**BELLEVILLE COMBINED LICENSE APPLICATION – RESPONSE TO REQUEST FOR
ADDITIONAL INFORMATION – GROUNDWATER**

Reference: Letter from Joseph Sebrosky (NRC) to Andrea L. Sterdis (TVA), Request for
Additional Information Letter No. 062 Related to SRP Section 02.04.12 for the
Belleville Units 3 and 4 Combined License Application, dated July 3, 2008

Subject: Groundwater as discussed in the Final Safety Analysis Report

Figure RAI-636-1
Hydraulic Potential for Groundwater Flow
Between River Valleys

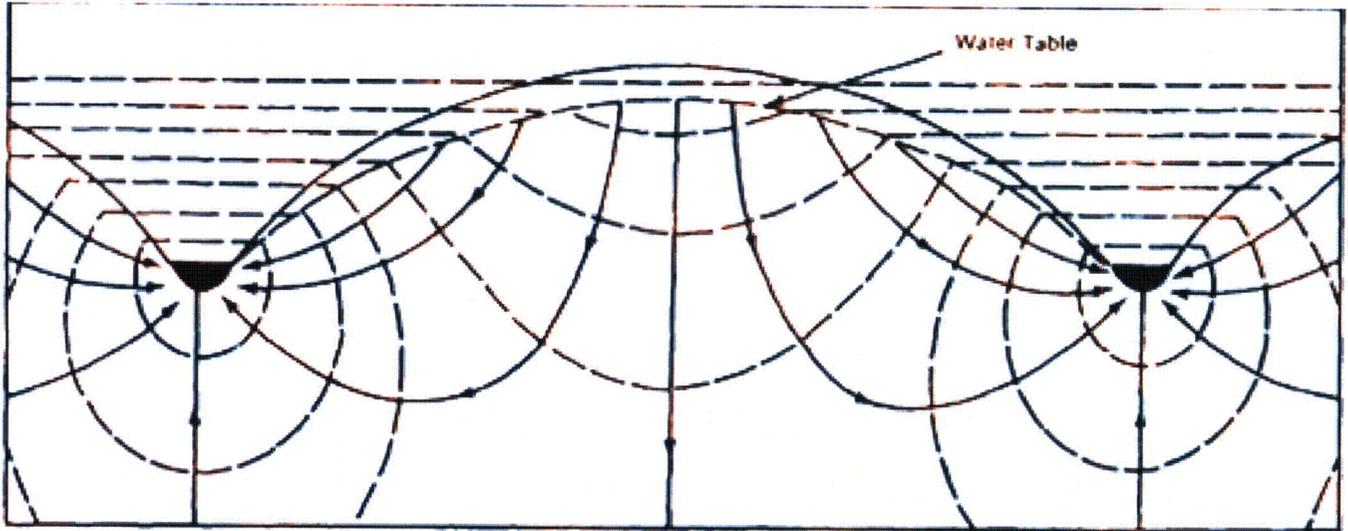
Given the potential karst development of the Knox Group and the Stones River Group, provide the technical basis for the assumption that these formations are hydraulically isolated from each other in the area of Town Creek. This issue is associated with Attachment 5, item 8, of the May 13 -16, 2008, hydrology-related safety site trip report dated June 12, 2008 (ADAMS accession number ML081610308).

Groundwater flow in river valleys will normally follow the surface topography prior to discharging to the adjacent river. Although the BLN site is located within a poorly developed, essentially fractured rock, subsurface groundwater system, the groundwater hydraulic characteristics behave similar to a granular groundwater system (Reference 1; Attachment 02.04.12-02A) in that flow within the fracture systems will follow basic hydraulic head principles, modified by being constrained to the fracture flow pathways. Water table groundwater flow in both systems will tend to flow toward the river (or perpendicular to equal contours of surface topography) with discharge to the river (Figure RAI-636-1; Attachment 02.04.12-02C) (Reference 2; Attachment 02.04.12-02B).

Figure RAI-637-1
Groundwater Potentiometric Surface
Response to Rising Water Levels in Nearby Creeks

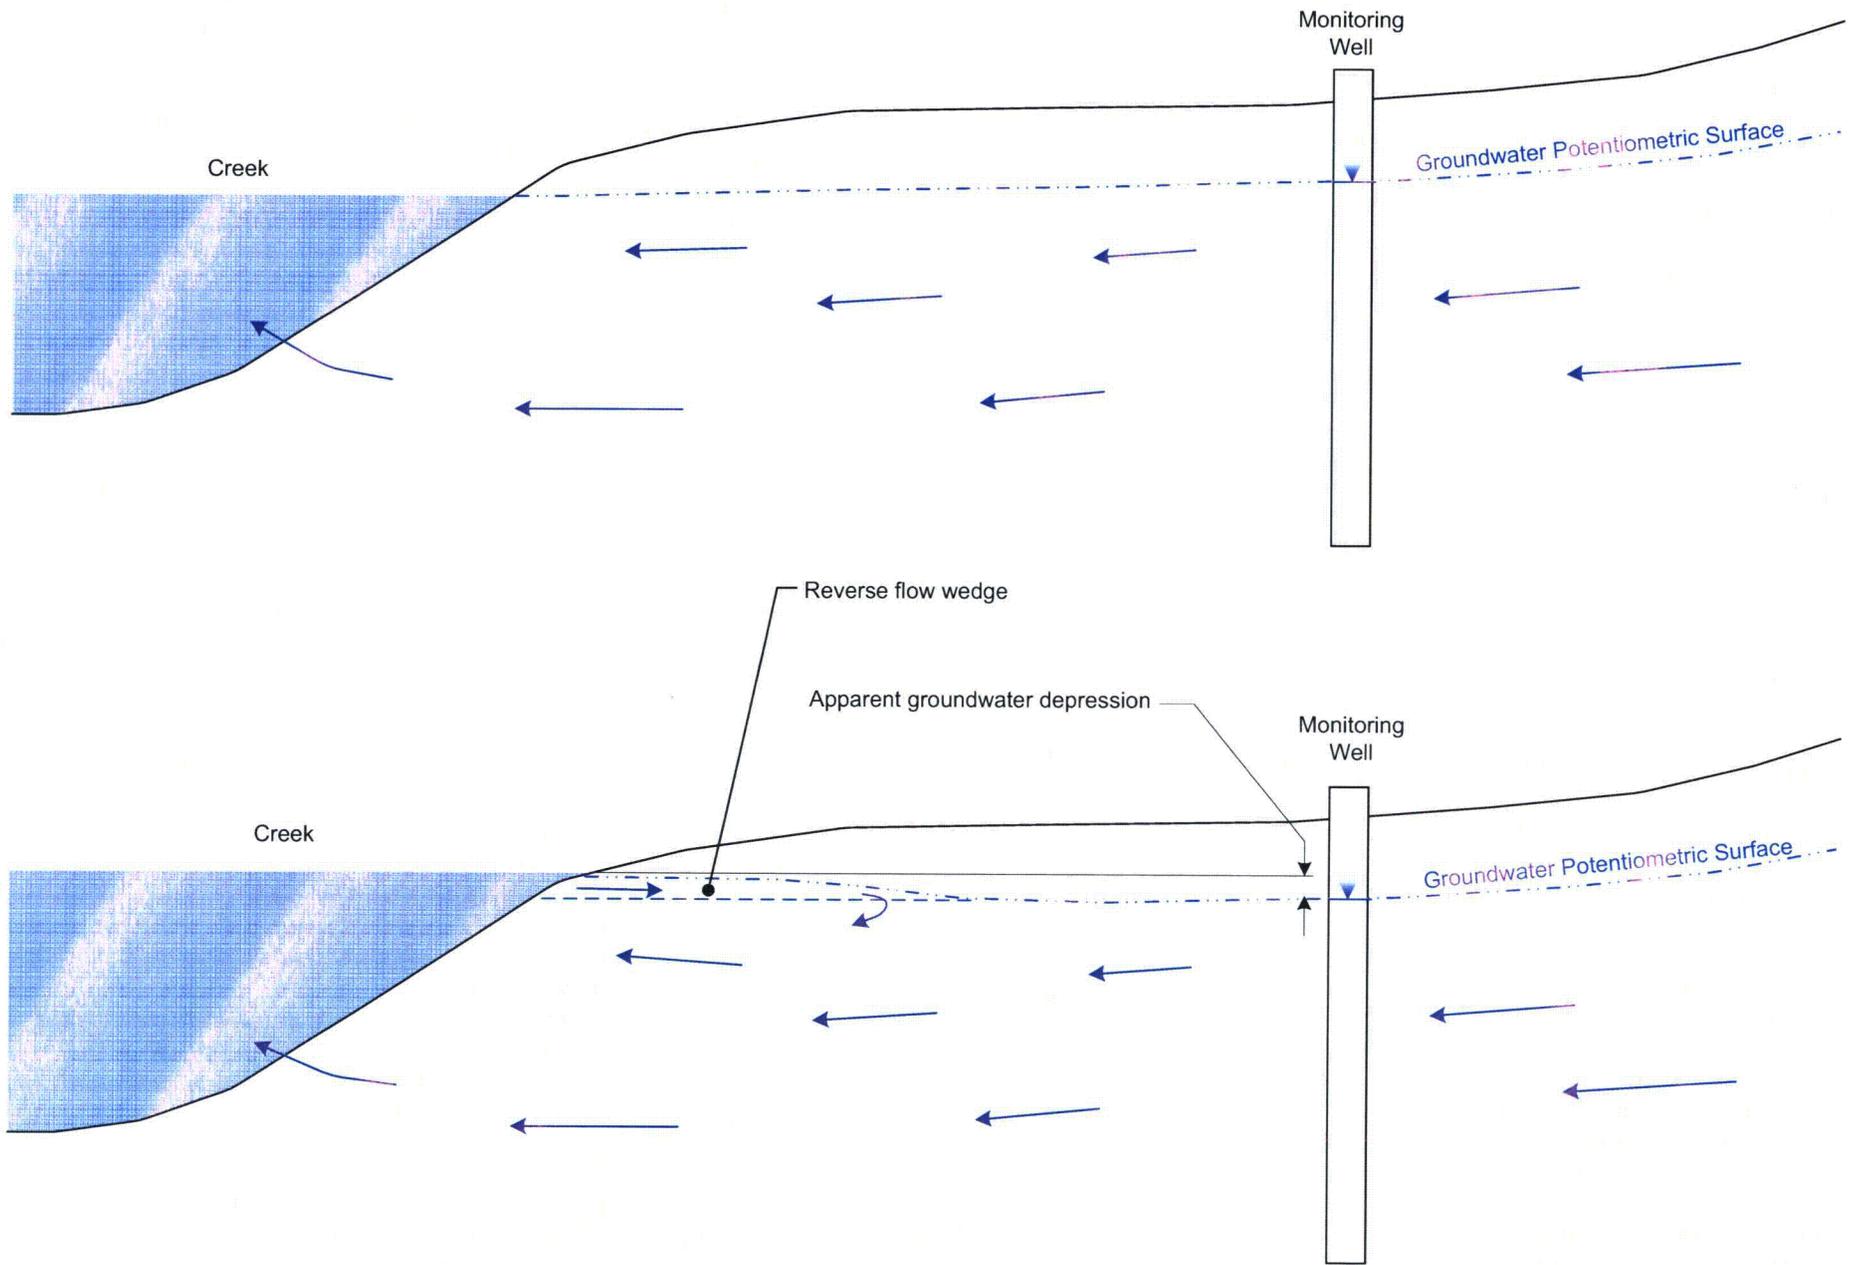
This interpretation of the groundwater head observations indicates downward movement of groundwater at MW-1212. Discuss why and how such downward movement of groundwater may occur.

This statement from the FSAR implies that the downward movement of groundwater (drainage into the lower bedrock zone) occurs only during relatively dry periods. Provide the technical basis for this conclusion. If the implication was not intended, provide a discussion of the relevance of the downward movement of groundwater at this location to subsurface pathways.

Please provide any other plausible explanations for the groundwater depression.

An additional plausible explanation of the groundwater depression is a rise in reservoir level during the monitoring time period. If the river or creek stage (level) rises, with no additional precipitation input to the adjoining land, then surface water will begin recharging the groundwater aquifer along the shores of the river or creek, setting up a reverse groundwater flow (Reference 1, page 6). If the subsurface surrounding the river or creek has a high permeability (sand, gravel, etc.), this reverse flow equalizes rapidly to form a new, stable phreatic surface; however, if the subsurface is of low permeability, the equalization time may be very long, resulting in a much slower recharge and stabilization of the aquifer phreatic surface. If an adjacent monitoring well, located within this zone of influence, is gauged prior to equalization of groundwater levels to the new river stage, then the groundwater level in the monitoring well will be lower than the current river stage for that day, thus showing an apparent "depression" of the groundwater potentiometric surface at that monitoring well (Figure RAI-637-1).
